# BUCKHEAD ADDITION

WICHITA, SEDGWICK COUNTY, KANSAS

Re: 94-79 BUCKHEAD ADDITION (Final Plat)

At the regular meeting of the Subdivision Committee of the Metropolitan Area Planning Commission on Thursday, April 20, 1995, the above captioned plat was considered. The action of the Committee was to recommend that this plat be approved subject to:

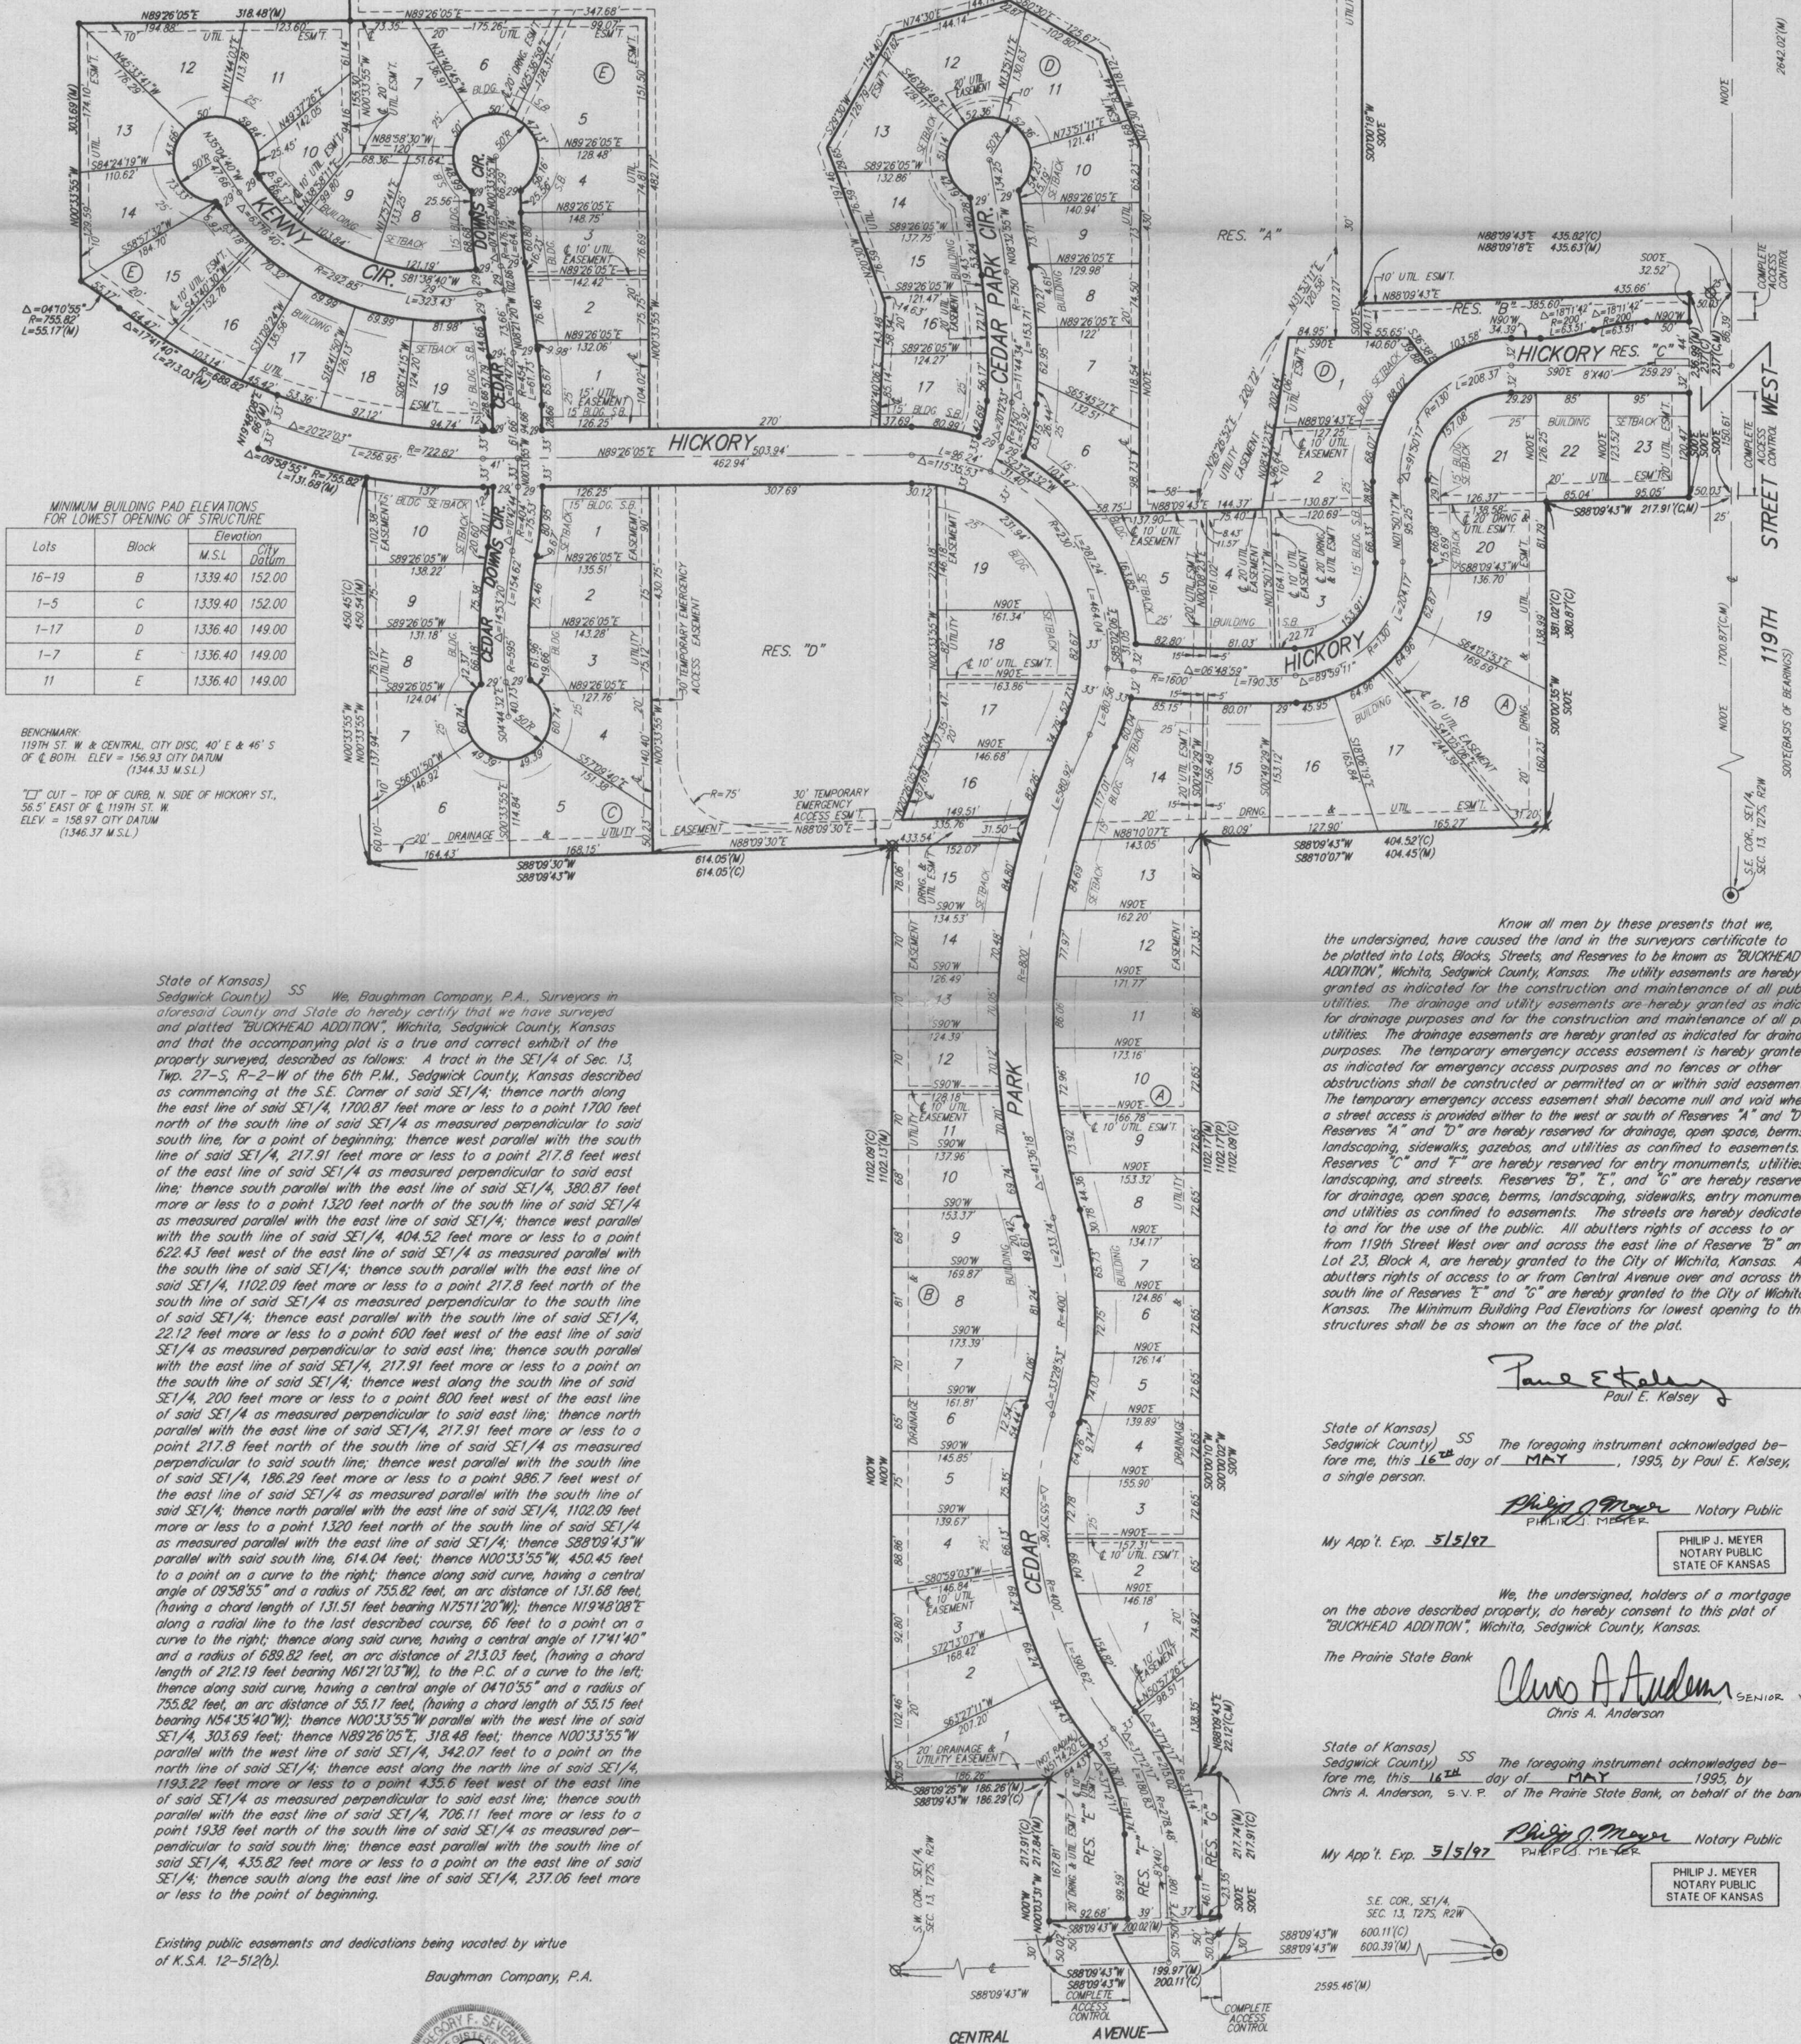
- ☒ A. Prior to this plat being submitted to the City Council of Wichita for review, this property shall have been annexed to the City. This will allow the lot sizes being proposed by the plat.

- ☒ B. The applicant shall guarantee the extension of sanitary sewer to serve the lots being platted. As necessary this guarantee shall include any needed off-site extensions and the provision by separate instrument of any associated off-site easements.

- ☒ C. The applicant shall guarantee the extension of City water to serve the lots being platted. This site shall also participate in the extension of City water along Central.

- ☒ D. The applicant shall guarantee the paving of the proposed interior streets. As indicated on the plat, Cedar Park/Hickory will require paving to the collector street status. In regard to sidewalks, the paving guarantees shall include a sidewalk on both sides of Cedar Park/Hickory (a collector), one side of Hickory as it extends out to 119th Street West and one side of the looped street Firefly-Birch-Bay Country.

- ☒ H. In regard to street names, circles instead of courts should be used in nearly every case of a

cul-de-sac street. The two cul-de-sac streets noted as Cedar Down Ct. should for instance be named Circles. Also, this street should be called Cedar Downs, which agrees with the existing name in this area. In regard to Kenny, this street should be a circle.

L. In order to make the Reserves more accessible to the residents in the addition, it is recommended that additional access, such as an extension of the Reserves be provided in such locations as in the area of Lots 5 and 6 from Hickory to Reserve A.

M. For lots adjacent to the Lakes, the final plat tracing shall reference the required minimum building pad elevations in Mean Sea Level as well as City Datum. The platting of the minimum building pad elevation shall be noted on the face of the plat as well as in the plat's text.

N. Since this property is establishing minimum building pad elevations, the face of the plat shall reference the location and elevation of permanent on-site and off-site benchmarks. Section 5-402(N).

- T. On the final plat tracing, the platlor's text shall be amended to note that streets are being dedicated to and for the use of the public.
- U. For Lots 1 & 2, Block D a 25-foot building setback to Hickory shall be platted.

- Z. The final plat shall indicate the utility easements requested by K.G. & E. Bell which is indicated on the enclosed "marked" copy of the plat.
